Waterfront Flood Mitigation Project Discussion

September 4, 2025

^{*} Conceptual Drawing credit: Mr. Al Cox, AIA 7/3/2025. Subsequent sheets include markups and notes by the City of Alexandria

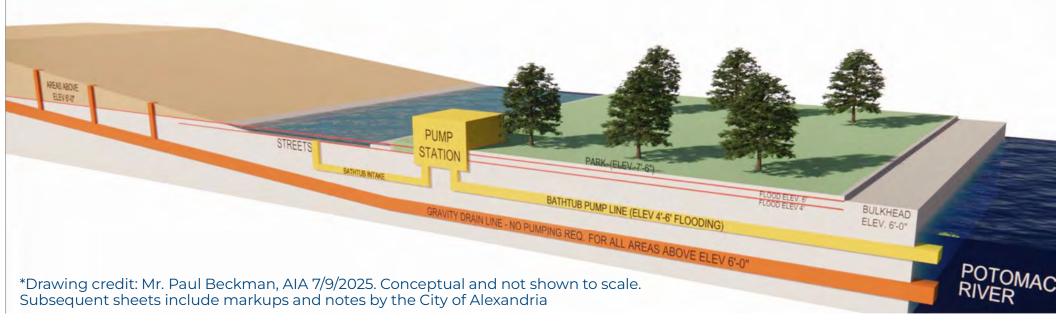
This theoretical concept proposes a <u>dual</u> stormwater system which, after evaluation by engineering analysis and modeling:

- Does not substantially reduce the footprint/size of the pump station
- Increases construction impacts as compared to the City's current proposal:
 - Would require deep excavations and deeper outfall structures than is feasible/sustainable
 - Would still require phased street closures and significant pipe replacement/installation
 - Would likely increase utility conflicts and street disruption due to utility relocations
 - Would likely increase construction impacts to residential areas and park areas (including Founder's Park)
- May increase overall project and construction costs

Pump Station Size Constraints

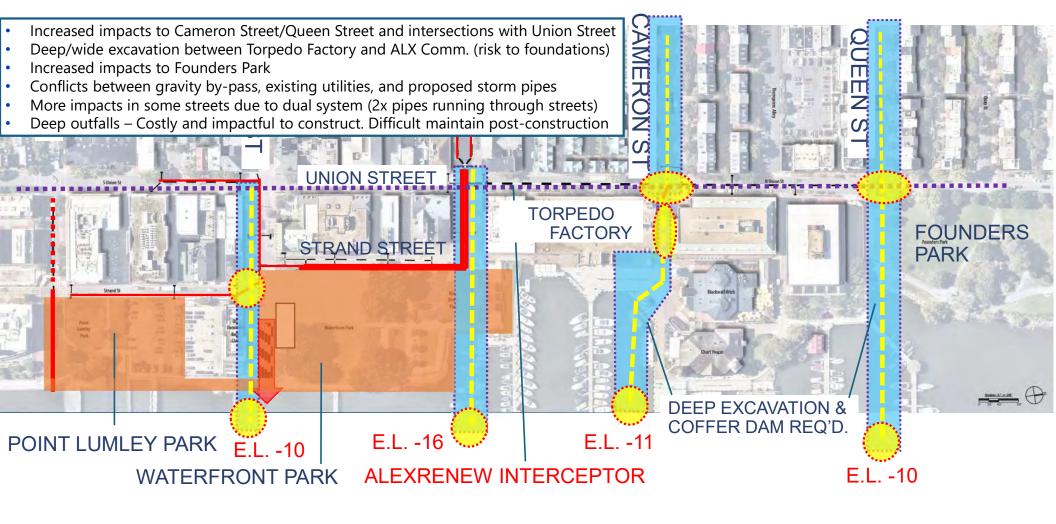
This will not substantially reduce the size of the pump station as suggested by AWA.

Minimum Clearance Requirements per NEC and/or Equipment Manufacturer

Meeting the requirements prevents the 2nd floor from being reduced, even with the elimination of a VFD Pump Controller.

Even if we could reduce pump station pumping capacity by 50% (to ~ 115 MGD) - only one Pump/VFD Pump Controller would be eliminated.

AWA Concept - Flooding at the Storm Peak

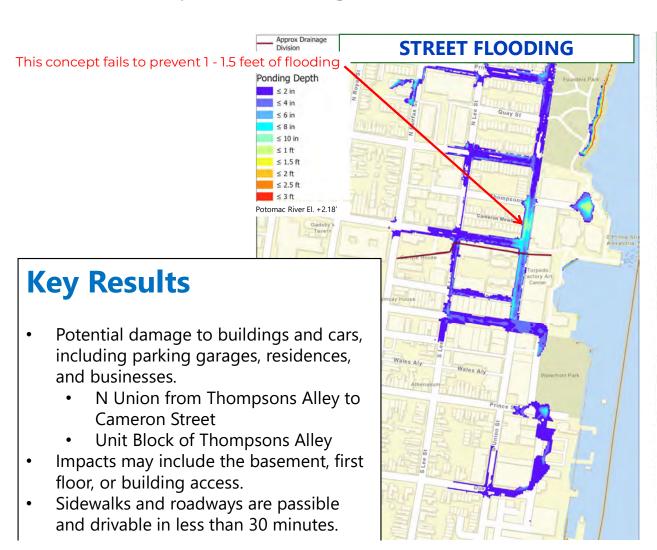
Replace exist. outdated storm sewers and drain directly to the river

Deployable flood barrier at N Union —

Elevate bathtub streetscape to 4' where possible & drain to pump --->

4. Reocated pump station

Delete proposed new Union St. pipes

A deployable pump can be further evaluated for this location; however, it won't reduce the pump station size.

Potential that manhole at Cameron/Union intersection could be used as a point for bypass pumping.

Would require further analysis of capacity of a trailer-mounted bypass pump on Union St. Potential route for discharge hose to the Potomac River shown.

The bypass pump would need to be sized to handle the floodwater that accumulates behind any the deployable barrier.

If northern catchment basin infrastructure is not enlarged, existing storm sewer network quickly fills up and the excess runoff/ponding fills the bathtub.

Approximately 260,000 gallons of water is in the bathtub during the design storm after the underground storm drainage system is full.

Raising the grade will spread out this volume of water to a wider footprint and will not reduce the capacity requirements of the pump station.

Additional storm sewer improvements, outside the proposed project area, will be required to collect this water.

Raising the grade across a large area will require significant building/home access improvements along with challenges in meeting ADA requirements for sidewalks, crosswalks, etc.
